TEXAS COMMISSION ON ENVIRONMENTAL QUALITY

July 3, 2009

Re: Edwards Aquifer, Comal County
NAME OF PROJECT: Cibolo Trails, located in far west Comal County, on the east side of Battle Intense, approximately 1000 feet south of Keenland, Fair Oaks Ranch, Texas
TYPE OF PLAN: Request for Approval of a Modification of a Water Pollution Abatement Plan (WPAP); 30 Texas Administrative Code (TAC) Chapter 213 Edwards Aquifer
Edwards Aquifer Protection Program ID No. 1979.01; Investigation No. 743272; Regulated Entity No. RN103098885

SITE GEOLOGIC MAP : (LEGEND)
SITE GEOLOGICAL UNIT : Qal - QUATERNARY ALLUVIUM
FLUVIAL TERRACE DEPOSITS.
SITE SOIL UNIT : (BoB) - BOERNE FINE SANDY LOAM,
1 TO 3 PERCENT SLOPES.

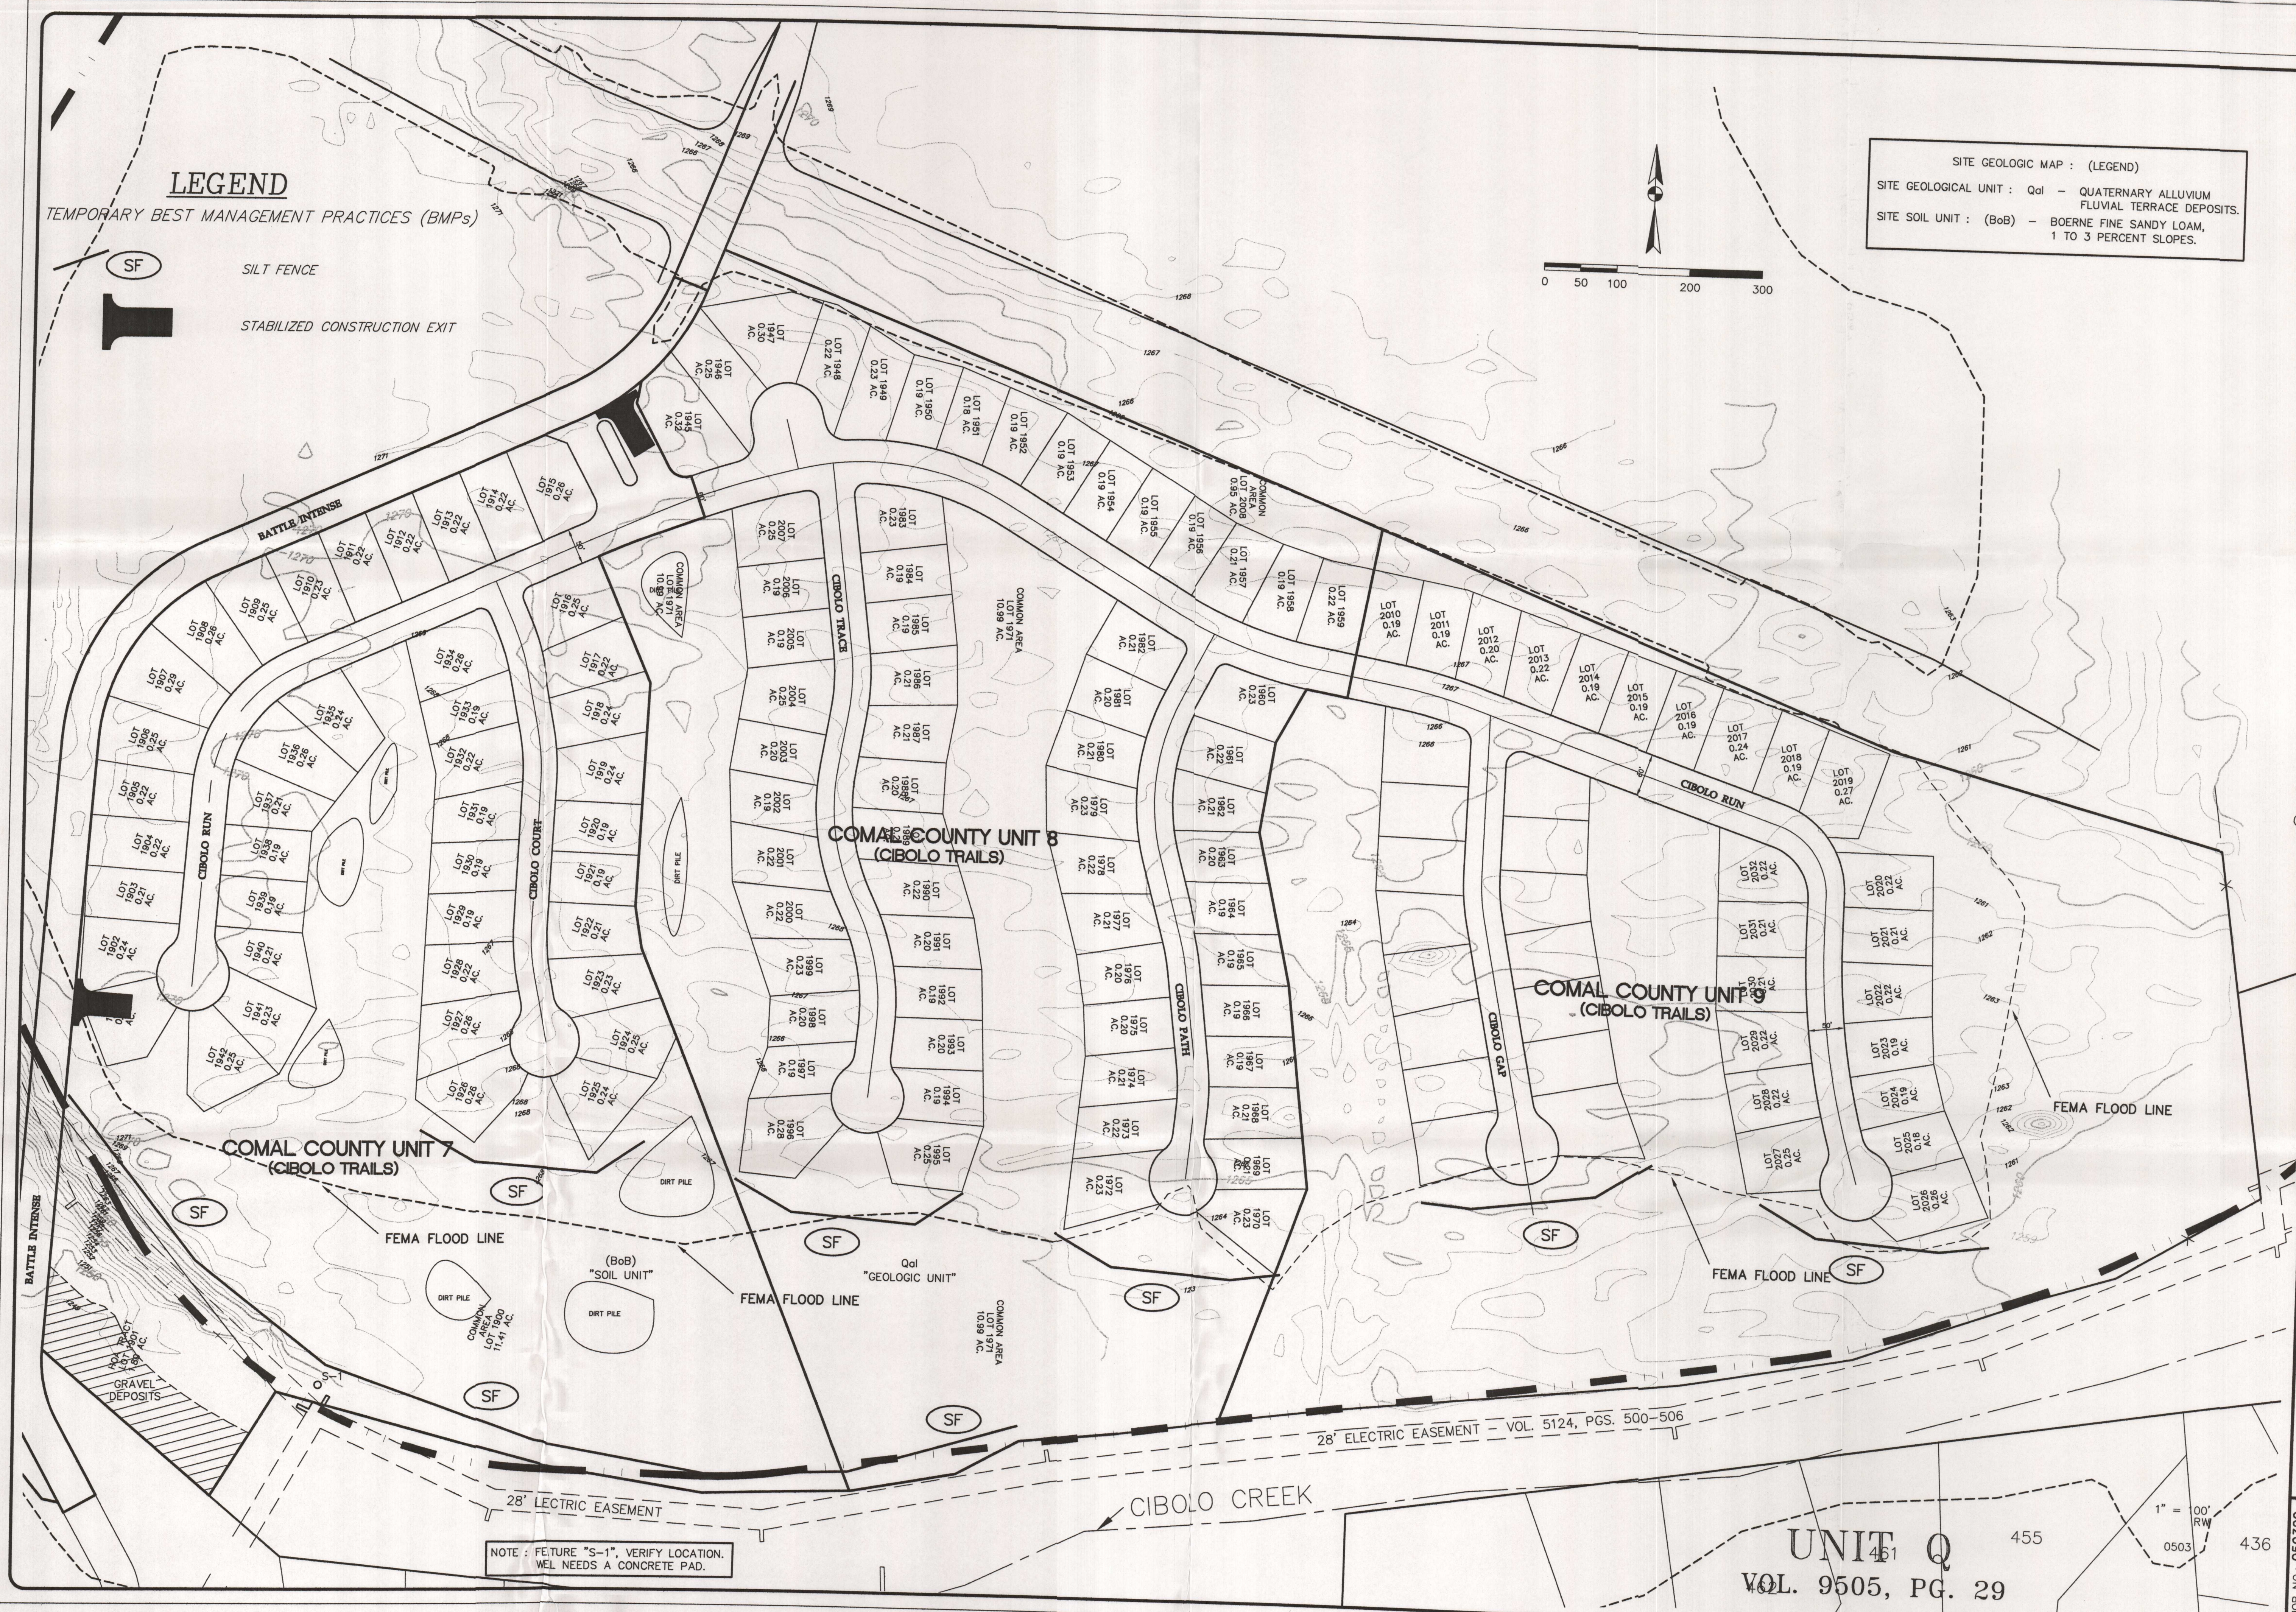
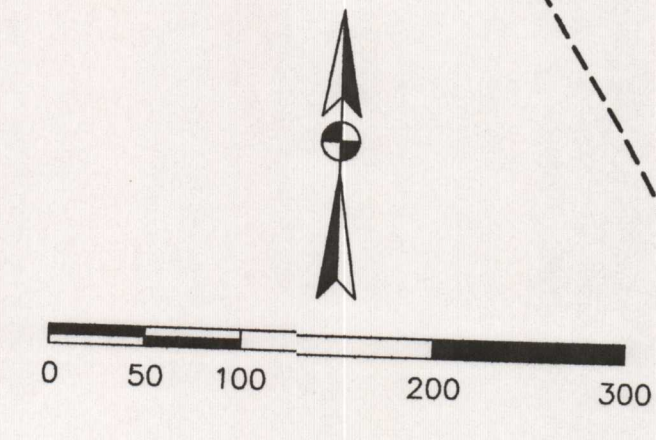
NOTE : FEATURE "S-1", VERIFY LOCATION.
WEL NEEDS A CONCRETE PAD.
